Project Office, Room 308, Town Hall, MANCHESTER M60 2L1
+44 (0) 7970 097 432
www.purcelluk.com

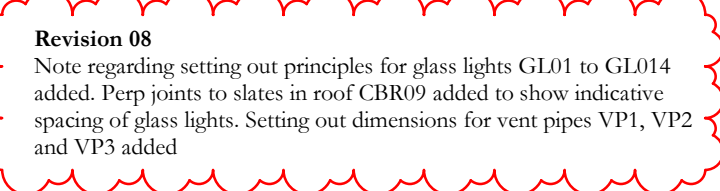
Revision 06
Location and angle of slab edge and upstand at west side of plant deck adjusted based on site survey of existing beam and rafter location.
Perimeter abutting existing stone and brick walls to be cast against face of existing masonry not set into walls

Revision 05
Setting out dimensions and sizes of openings indicated. Notes explaining principles for setting out edges of concrete deck added.

Revision 04
Vent dormer reference CBR09_01 omitted added. Existing frameless glass lights G1J01 to G1J14 and new vent pipes VP01, VP02 and VP03 added to CBR09. Rainwater outlets RWP 102 and RWP 103 added to CBRp01. Opening for smoke vent and openings for ducts CBRp01_Us2 and CBRp01_Us3 added to CBRp01. Existing stair added to CBR03. Plant screen changed from louvres to solid wall and extended to roofs and walls on north and south sides. Gentries omitted from lead roofs to courtyards and substituted with guardrails.

Revision 03
Vent dormer references added. Drawing re-issued for construction

Revision 02
Gantries added
